REMARKS

In an Official Action dated March 2, 2006, the Examiner rejected the pending claims, objected to the drawings and the specification. Applicants request that the Examiner reconsider the rejection of claims 1-4 and 21 and favorably consider newly presented claims 22-30.

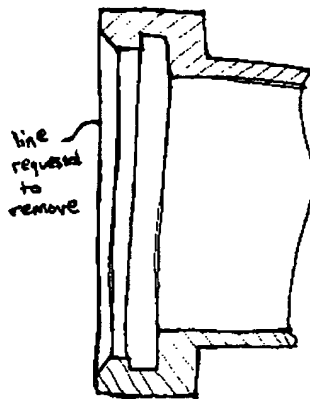
The Examiner has objected to the drawing in Fig. 2 as improperly showing the chamfer on the flange 55. As previously mentioned, the flange is drawn correctly.

In the following drawing, the outer sleeve is shown separated from the rest of the mounting device and the sectional is taken along a different line so that the sectional view shows the solid portion of the outer sleeve. The line that the Examiner has requested to be removed is shown in the drawing. As can be seen in the following drawing, clearly the line from the chamfer is visible in the figure. Similarly, in Fig. 2, the line would also be visible except that other components are covering the line except for the short line element that the Examiner has requested be removed. Since the lines are proper, Applicant requests that the Examiner reconsider the objection to the drawings.
